Access Compliance Report

Public Rights-of-Way

(Curb Ramps)

Intersection ID: 10025885	Main Street: ELIZABETH_AV	Cross Street: N/A	Location: S
ADA ID: 37959117842C	Ramp Type: Perp	Initial Pass/Fail: Pass	Overall Compliance: No
		Severity Score: 0.25	
Codes/Mitigation Info/Possible Solution		Field Measurements/Component Compliance

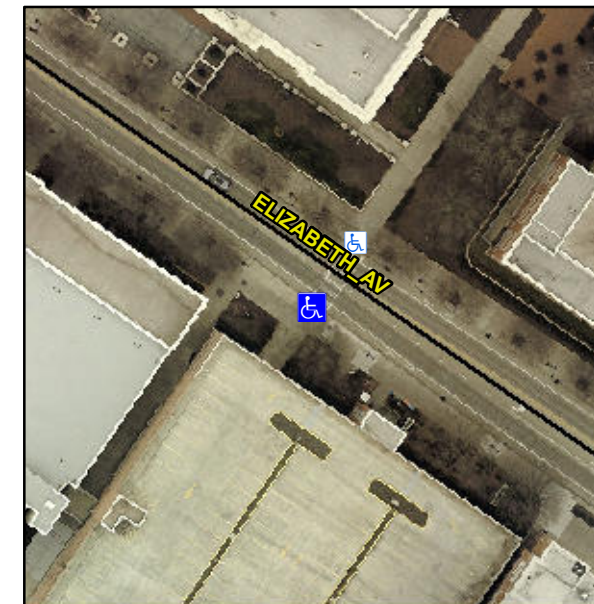
Not Found, R304.5.3, R304.2.2-Perp, R304.3.2-Para

Compliance	Description	Data	Compliance	Description	Data
N/A	Ramp Length (in)	84.0	Yes	Ramp Slope (%)	7.8
Yes	Ramp Width (in)	98.0	No	Ramp XSlope (%)	3.9
N/A	Flare Type LT	Sloped	N/A	Flare Type RT	N/A
N/A	Flare Slope LT (%)	9.7	Yes	Flare Slope RT (%)	2.1
N/A	Flare Traversable LT?	Yes	N/A	Flare Traversable RT?	Yes
Yes	Landing Length (in)	78.0	Yes	DWS Provided?	Yes
Yes	Landing Width (in)	98.0	Yes	DWS Contrast?	Yes
No	Landing Slope (%)	4.3	Yes	DWS Length (in)	24.5
No	Landing X Slope (%)	3.5	Yes	DWS Full Width?	Yes
N/A	Landing Curb? (Y/N)	No	Yes	DWS Offset (in)	0.0
N/A	Shared Landing?	No			
Yes	Gutter Ponding?	No	Yes	Gutter Slope (%)	1.4
Yes	Gutter Lip Ht (in)	0.0	Yes	Gutter X Slope (%)	2.7
N/A	Painted X Walk1?	Yes	N/A	Painted X Walk2?	N/A
	X Walk 1 Direction	To NE		X Walk 2 Direction	N/A
N/A	X Walk 1 Width (in)	111.0	N/A	X Walk 2 Width (in)	N/A
	X Walk 1 Slope (%)	2.8		X Walk 2 Slope (%)	N/A
	X Walk 1 X Slope (%)	2.8		X Walk 2 X Slope (%)	N/A

Remove & Replace Entire Ramp.
